Appendix B: Supplement to HydroQuest December 5, 2022 report titled: *Proposed Terramor Glamping Project: Hydrologic and Land Use Based Justification for Issuance of a Positive SEQRA Declaration*

RE: Terramor Failed to Document Sufficient Water Supply Availability, Adverse Impact to Neighboring Homeowner Water Supplies, Wetland Impacts, and Potential Water Quality Degradation of Sacred Pond Waters Downstream of their Wastewater Discharge Location - A Negative SEQRA Declaration and/or a Public Hearing are NOT Warranted Because Significant Adverse Environmental Impacts are Clearly Demonstrated in the Limited Number of Homeowner Wells HydroQuest and Mid-Hudson Geosciences Were Able to Monitor During Terramor's Three Pumping Tests

Figure 18

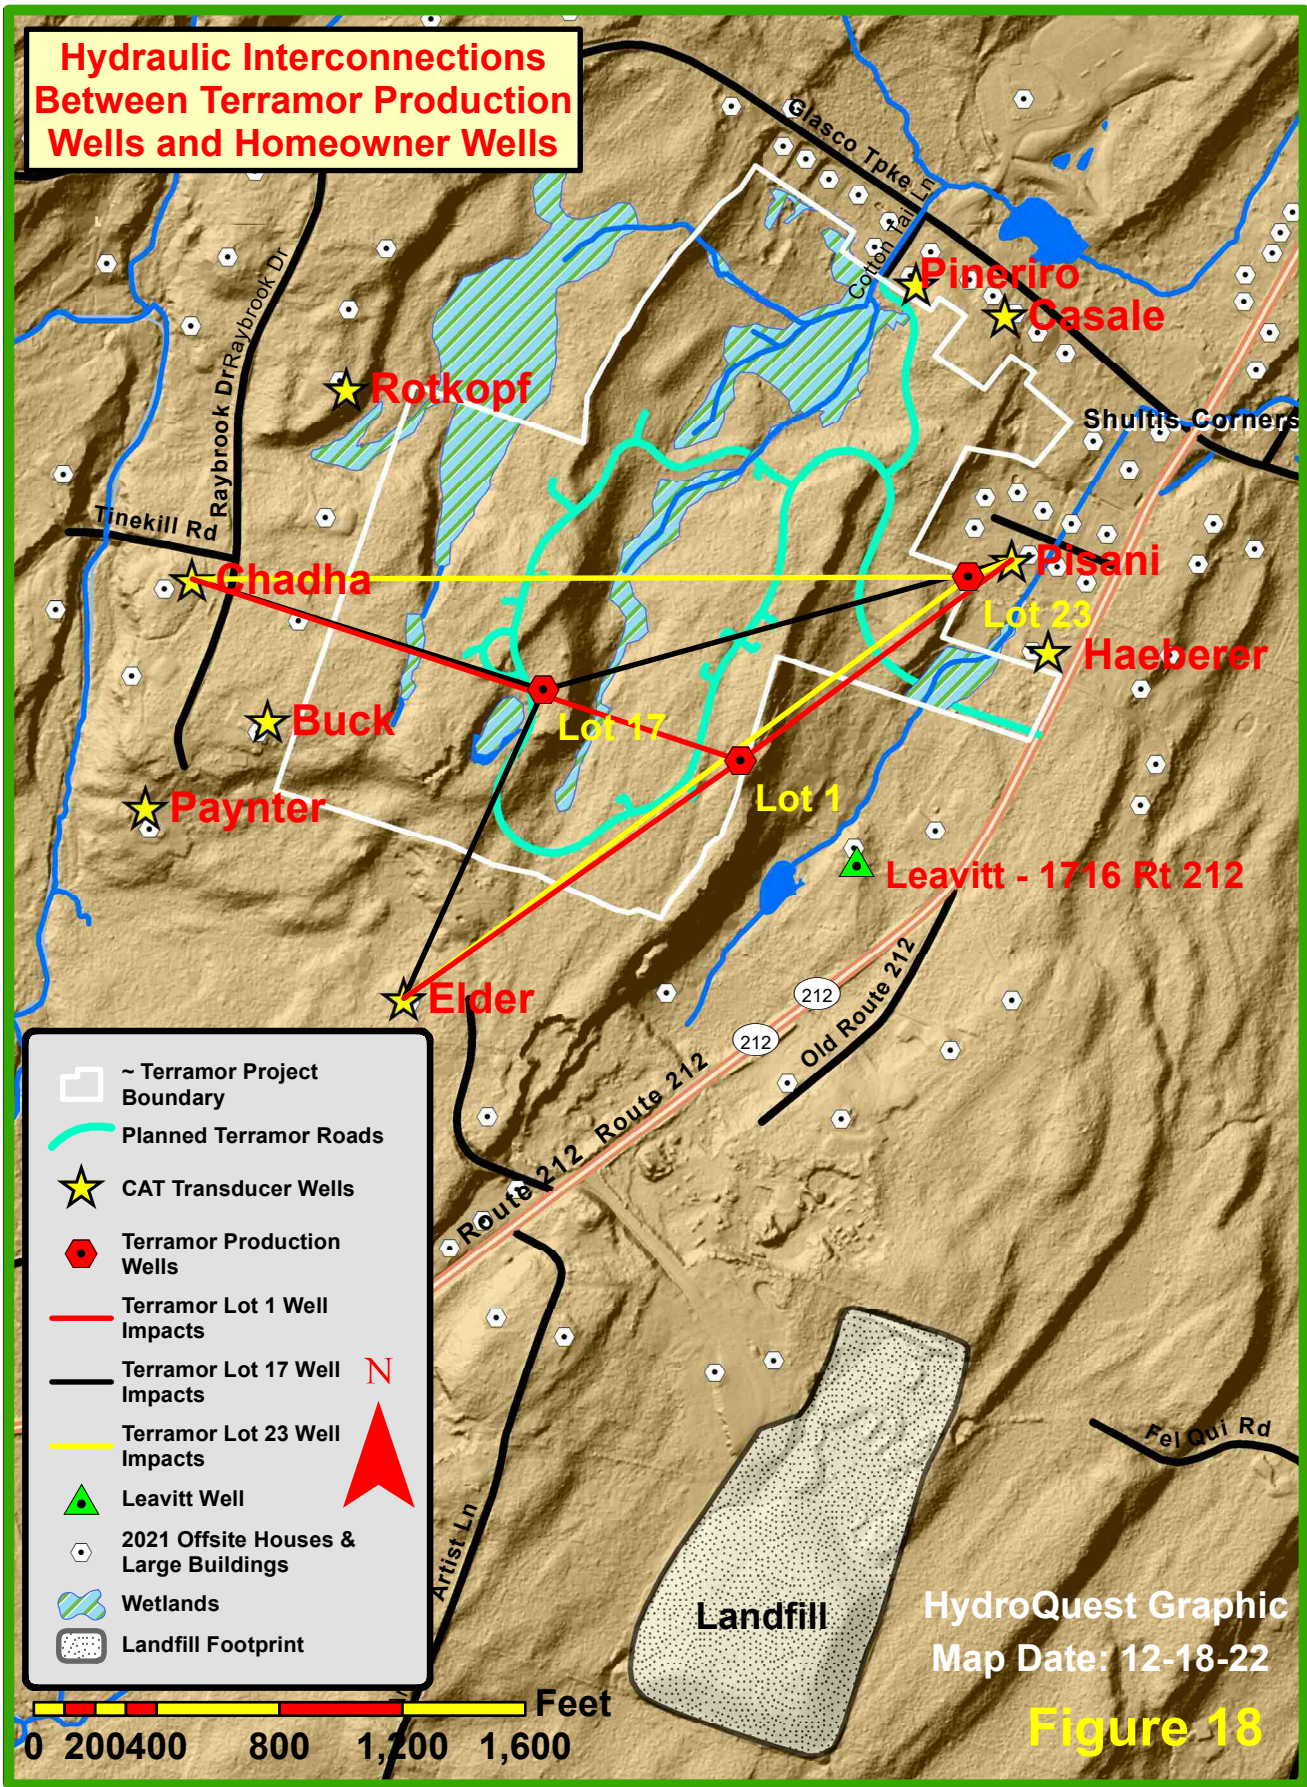
- Figure 18 shows approximate fracture pathways that interconnect all three Terramor production wells with the Pisani, Chadha, and Elder homeowner wells extending outward for over 2,500 feet;

- Importantly, pumping water from each of the Terramor production wells impacted the Pisani, Chadha, and Elder wells during each test. Figure 18 shows the hydraulic interconnections between production wells and homeowner wells, at distances to at least 2,500 feet from production wells;

- Four offsite homeowner wells were monitored by C.T. Male “*to determine if the water use on the Terramor site will impact water levels in the wells on the neighboring properties.*” The four wells that Terramor monitored were Leavitt (1716 Route 2112), Pisani (11 Osnas Lane), Paynter (71 Raybrook Drive), and Pineriro (109 Cotton Tail Road). Their locations are shown on Figure 18;

- HydroQuest and Mid-Hudson Geosciences monitored nine homeowner wells, including the Pisani, Paynter, and Pineriro wells (Figure 18). Requests made to Terramor for information regarding which offsite wells they were going to monitor, as well as for a copy of their aquifer testing protocols were not satisfied. Nine wells were fitted with data loggers (aka transducers) programmed to record well water pressure every five minutes. Frequent data collection facilitates hydrogeologic interpretation;

- Well water impact was observed in the Pisani, Elder, and Chadha wells (Figure 18). Figures 19, 20, and 21 document impact on the Pisani and Elder wells. The Chadha well responded similarly to the Elder well. These three wells responded to each of the three pumping tests conducted by Terramor. Figure 21, for example, shows that about 1/3 of Elders’ available well water column was drawn down during Terramor’s first pumping test;

Figure 19

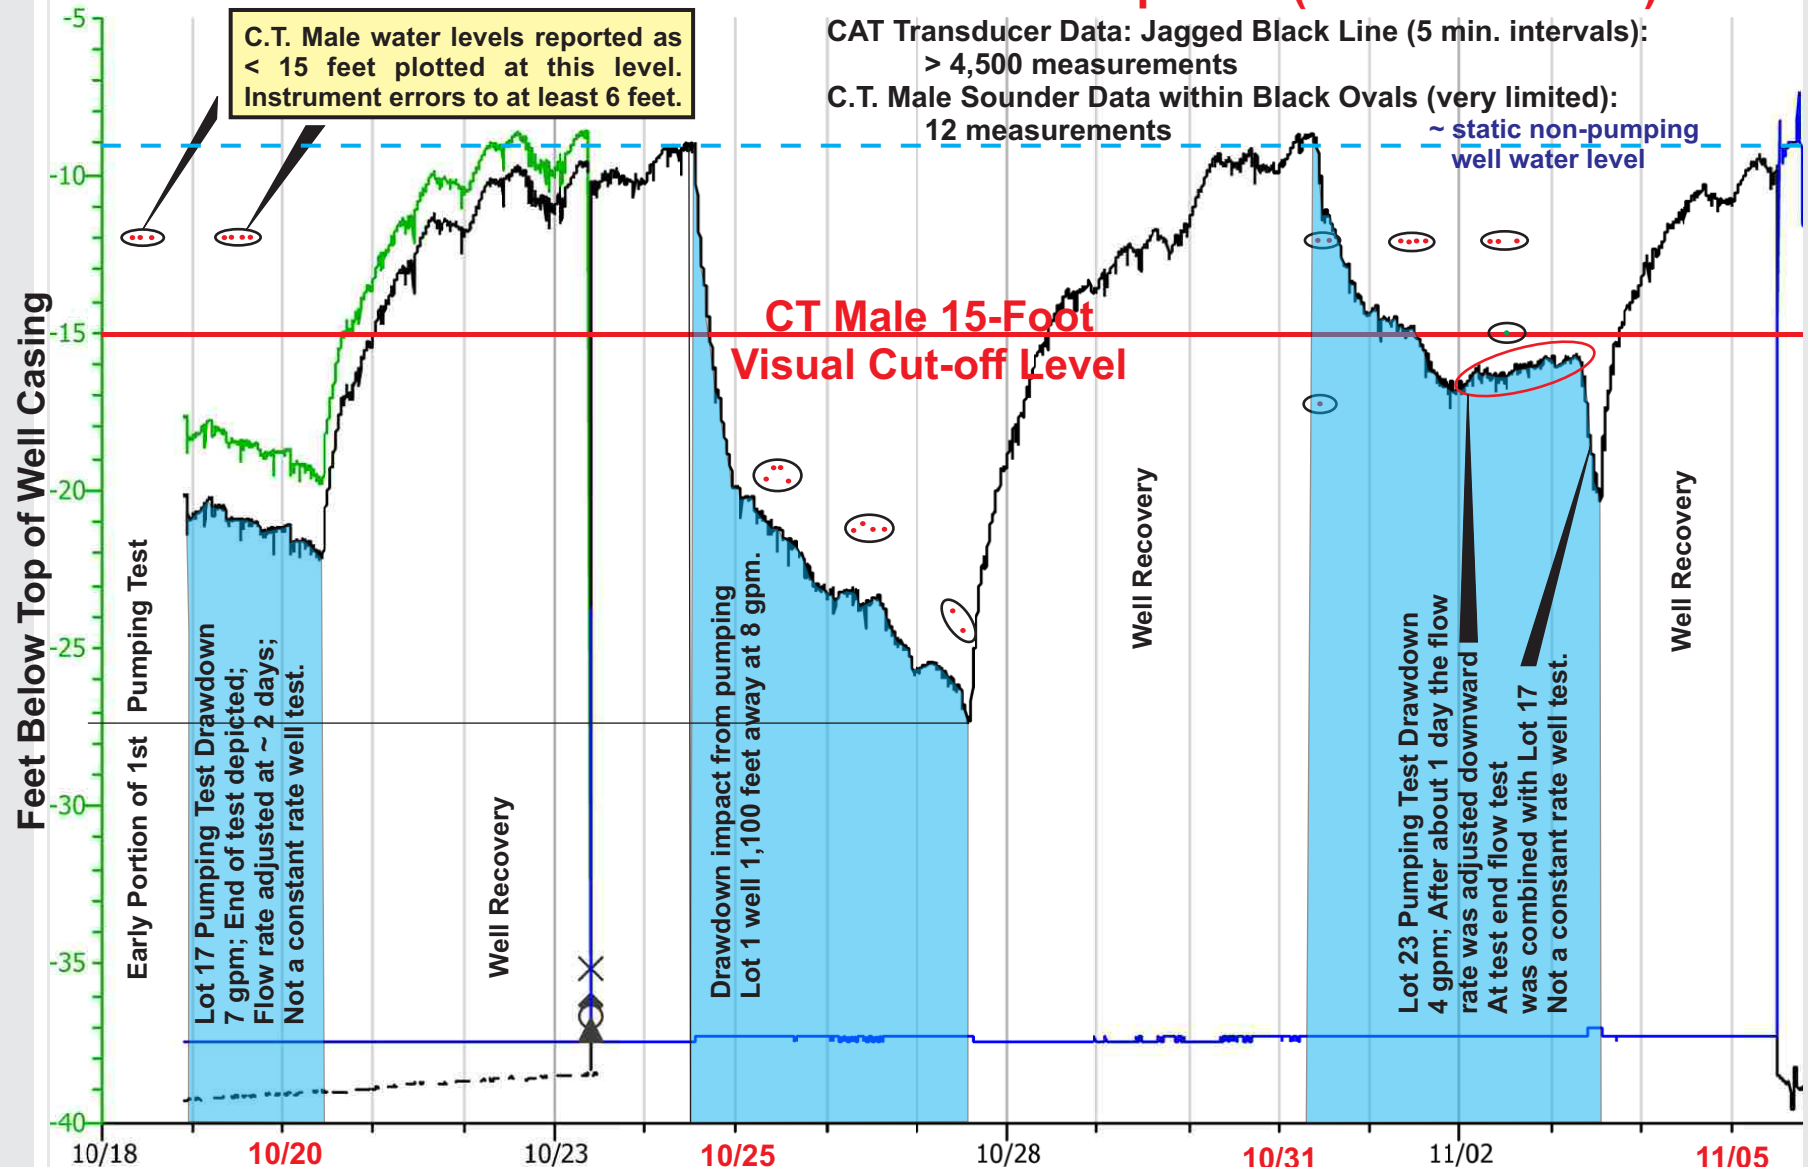
- Figure 19 accents the difference between Terramor's visual observations, their measured observations, and the highly accurate HydroQuest/Mid-Hudson Geosciences transducer data. Several issues resolve themselves on this figure. The red horizontal line reflects Terramor's observed limit of visual water depth assessment. Because 15 feet is a significant amount of water depth with an enormous amount of potential error, these visual observations were arbitrarily plotted at the -12-foot level below the top of the well casing. Looking, for example, at actual transducer level data plotted on 10-20-22, even if C.T. Male's water depth value were at -15 feet, their reading would be in error by 6 (six) feet. Other similar C.T. Male measurement errors may also be seen on Figure 19. Clearly, all of C.T. Male's well water data is suspect. As such, their aquifer testing data and conclusions should be discarded;

- Terramor's determination that no significant changes in water levels occurred in homeowner wells is also brought into question relative to the frequency of their well water measurements (besides the suspect nature of their reported well water level values). Reference to Figure 19, for example, shows Terramor's recorded water levels in the Pisani well. Individual Terramor readings are highlighted within black ovals. Over the duration of three pumping tests, Terramor made 12 (twelve) measurements to assess potential

pumping impact on the Pisani well. In this same time period, HydroQuest/Mid-Hudson Geosciences recorded water levels over 4,500 times in five-minute intervals. Interestingly, a close look at Figure 19 and the placement of Terramor's 12 measured water depth readings reveals that in the absence of the HydroQuest/Mid-Hudson Geoscience data, the observer would not know what the original static water level was at the start of the first, second, and third pumping tests. The Terramor data also fails to document any drawdown or recovery associated with the first and third pumping tests. For the most part, Terramor only documented a small portion of drawdown in the Pisani well during the second pumping test. However, no initial static/recovery level data was recorded to show overall change and the measured values are off by feet. Based on this incomplete and inaccurate data, Terramor found no significant impact to Pisani's water supply;

Figure 20

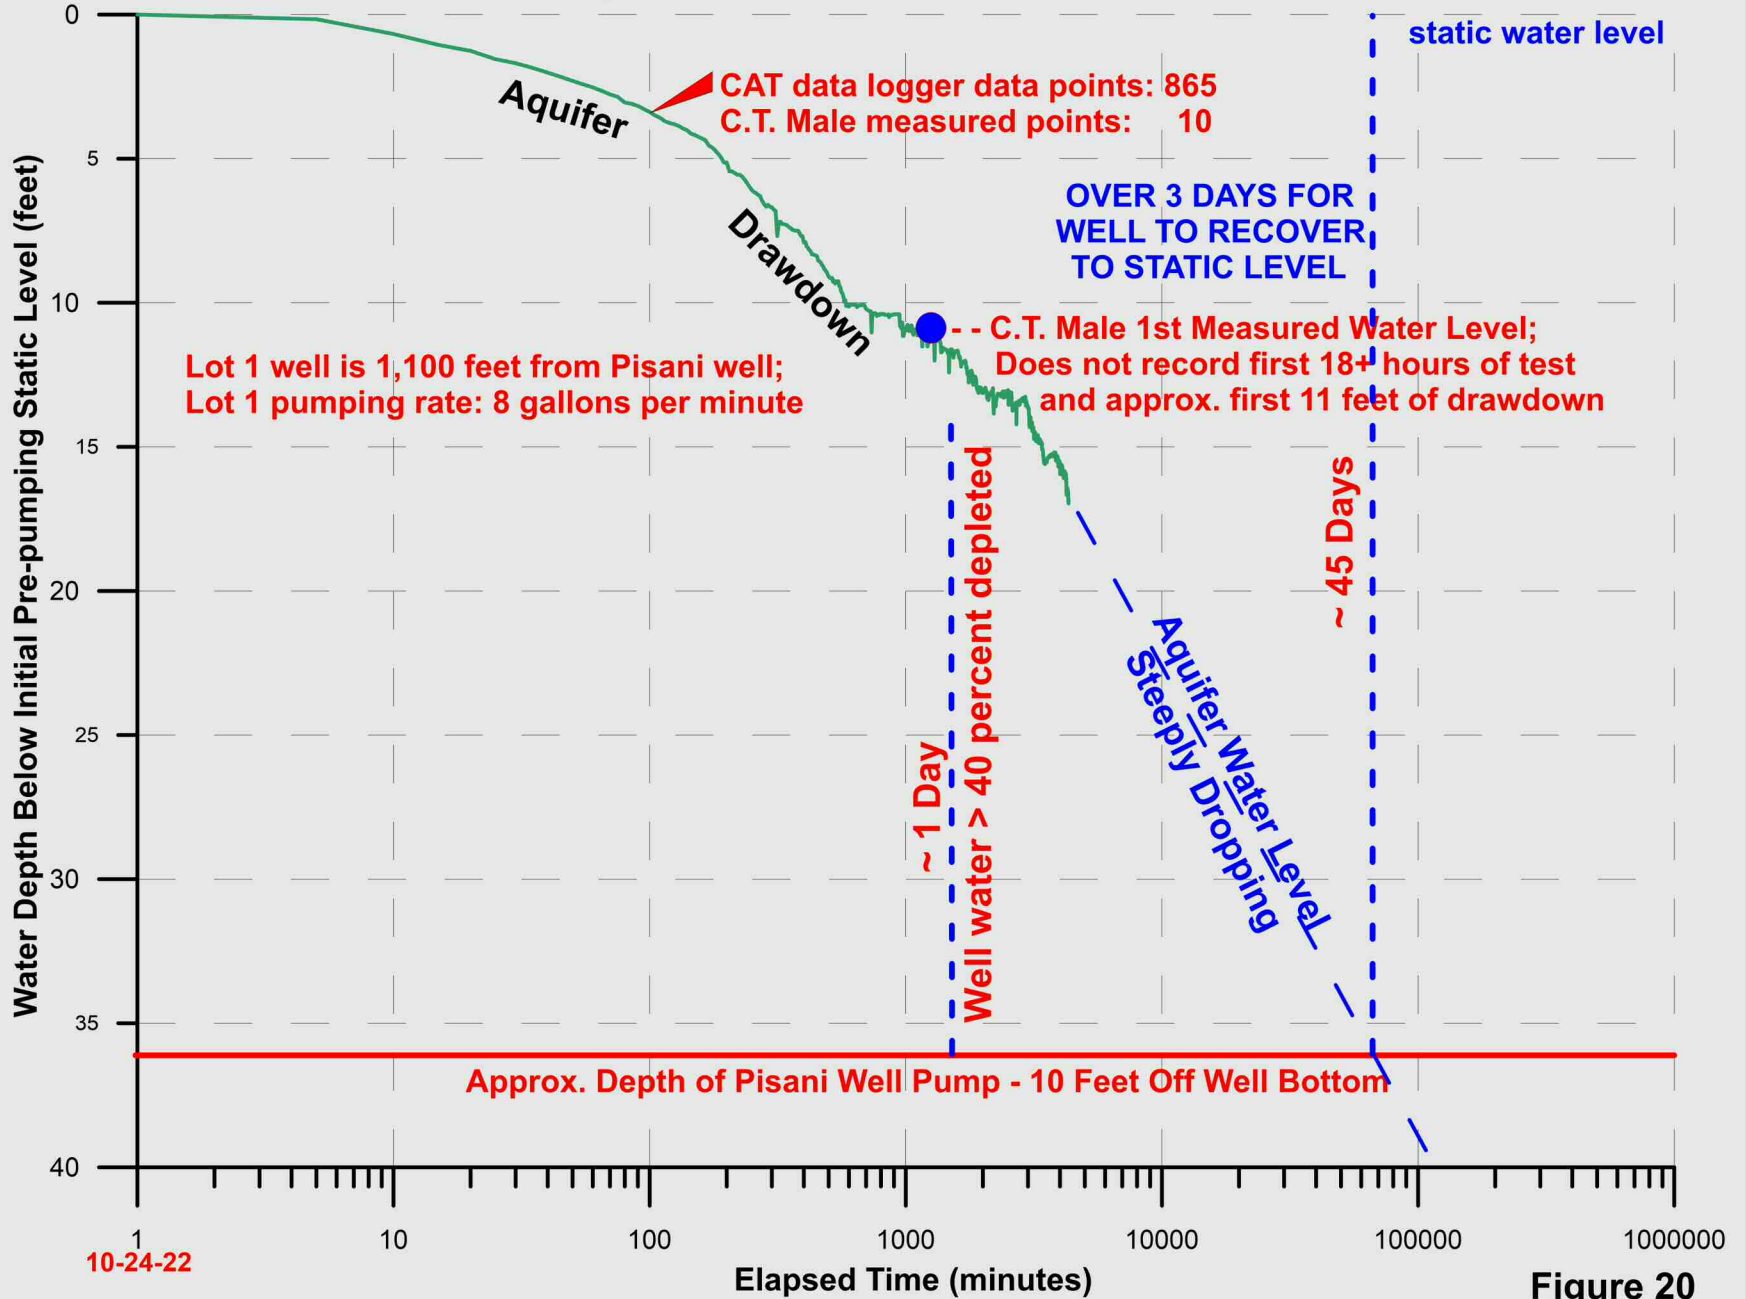
- Data from observation wells are usually more reliable and accurate than data from pumped wells, so time-drawdown plots from observation wells are most often relied upon to reveal the performance of an aquifer. Reference to Figure 20, for example, shows that even at a distance outward from Terramor’s Lot 1 production well to the Pisani well (1,100 feet), the aquifer is struggling to keep up with a demand of 8 gallons per minute. This impact is shown on the steep slope on the semilog plot as projected downward beyond the end of the drawdown data. This dashed line predicts water levels after longer periods of continuous pumping. Here, we see that this pumping would likely dewater the Pisani well within about 45 days. However, if Terramor’s production wells all draw groundwater from the same interconnected fracture set and more than one well is pumped at a time, as needed to meet Terramor water demand, the Pisani well may become dewatered before 45 days. If the aquifer had been able to keep up with the required demand from Terramor’s Lot 1 well, the stated highest yielding site well, the projected water level on the plot would be almost horizontal, not steeply inclined at a 60° angle. **Terramor has not demonstrated that there is sufficient groundwater to meet project demand. Terramor has demonstrated that water levels in offsite homeowner wells will drop significantly, likely leading to dry wells;**

Figure 20 shows that greater than 40 percent of Pisani's available well water was depleted by Terramor during their second pumping test. Figures 19 and 21 show that aquifer recovery following Terramor's pumping tests took days. Pumping of multiple Terramor production wells to meet project demand may result in dewatering some homeowner wells within a few months;

Figure 21

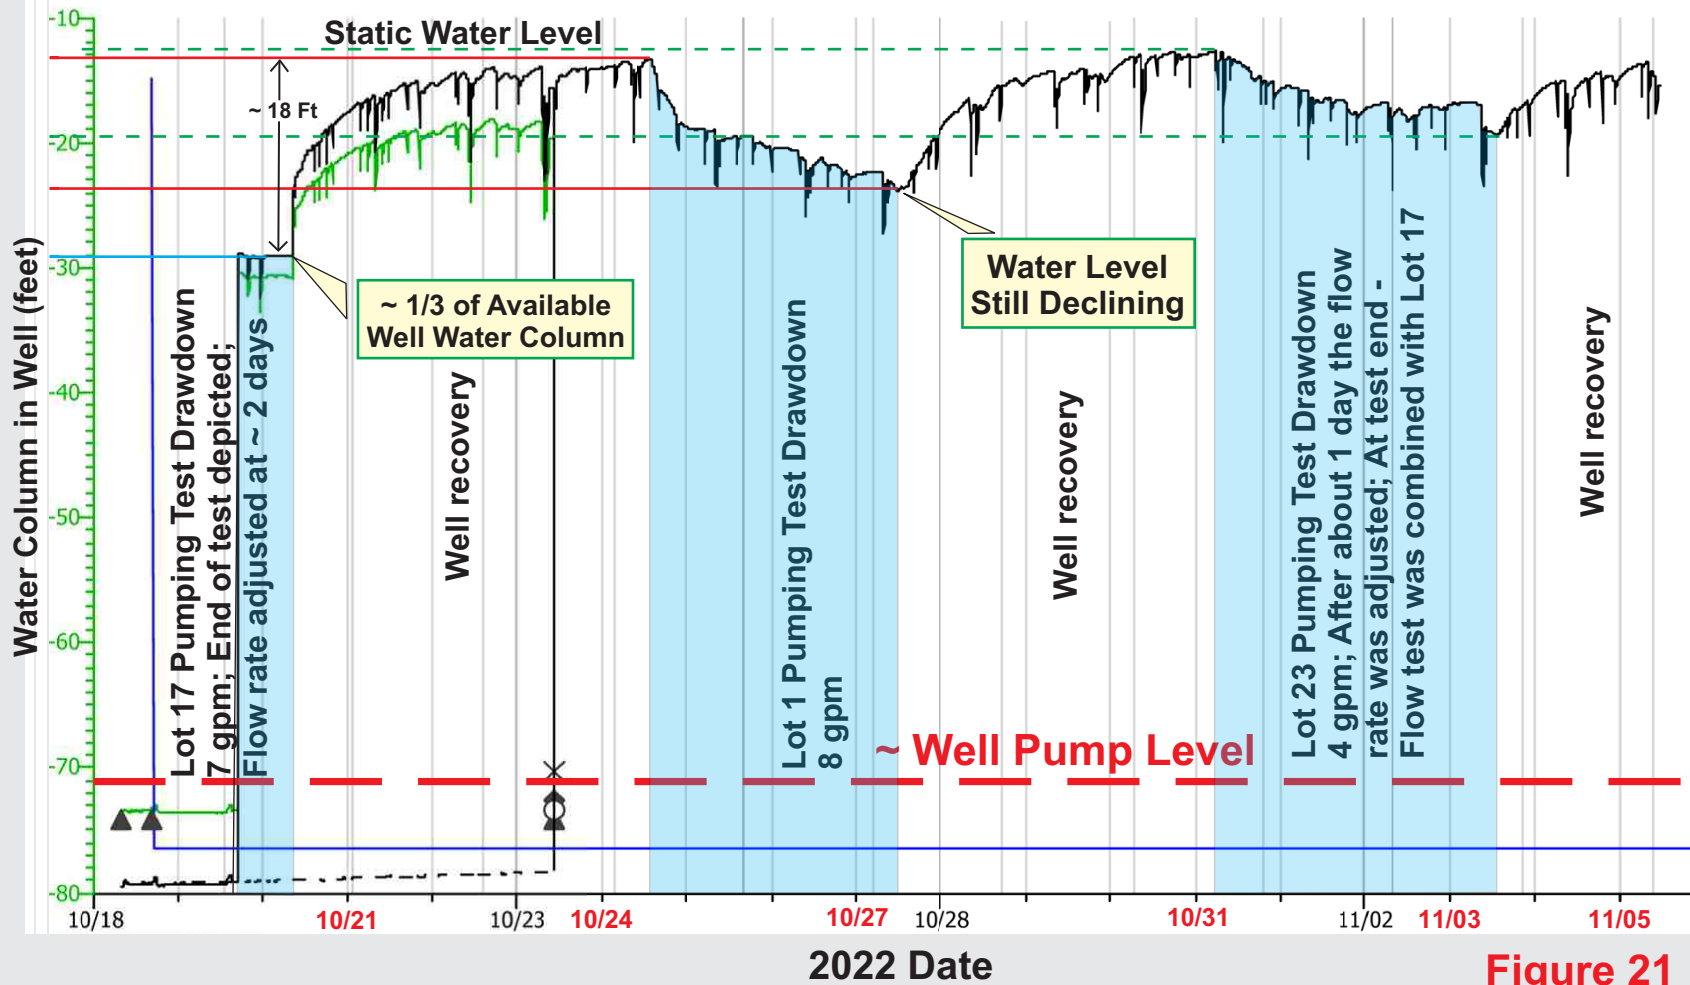
- Figures 19, 20, and 21 show portions of the Terramor pumping tests where aquifer drawdown is increasing when their pumps are turned off. This response indicates that the pumping wells are pulling in groundwater from ever greater distances outward to keep up with the pumping demand. The downward slope of the drawdown portions of the graphs indicate that aquifer equilibrium conditions have not been achieved such that production well yields can be maintained (i.e., water entering the area of pumping influence is significantly less than pumping well yield);
